UNITED STATES PATENT AND TRADEMARK OFFICE

APPLICATION NO.	FILING DATE	FIRST NAMED INVENTOR	ATTORNEY DOCKET NO.	CONFIRMATION NO.
10/021,922	12/13/2001	Marko Eromaki	442-010738-US(PAR)	2222
2512	7590	08/16/2005	EXAMINER	
PERMAN & GREEN 425 POST ROAD FAIRFIELD, CT 06824			CHIANG, JACK	
			ART UNIT	PAPER NUMBER
			2642

Office Action Summary	Application No.	Applicant(s)	
	10/021,922	EROMAKI, MARKO	
	Examiner	Art Unit	
	Jack Chiang	2642

Fig. 7

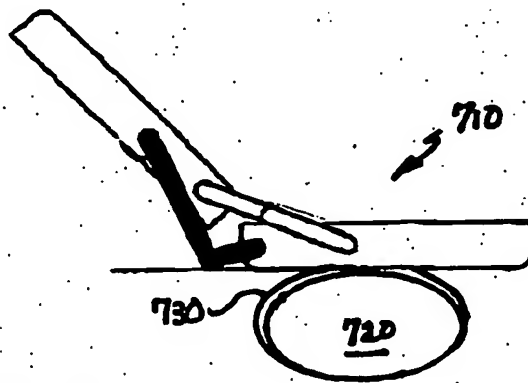
1. The drawings are objected to under 37 CFR 1.83(a). The drawings must show every feature of the invention specified in the claims. Therefore, the "... a wrist wearable form" called for in claim 17 must be shown or the feature(s) canceled from the claim(s). No new matter should be entered. (See also the argument section).

The examiner will duplicate applicant's original page 8, lines 6-7 as follow: "individual numbers from the display 12.". It is not seen that there is any support for the wrist wearable form of the device, not to mention the specific newly added feature in the newly added fig. 7. Therefore, proposed specification and drawing filed on 6/6/06 will not be entered.

Not
Approved
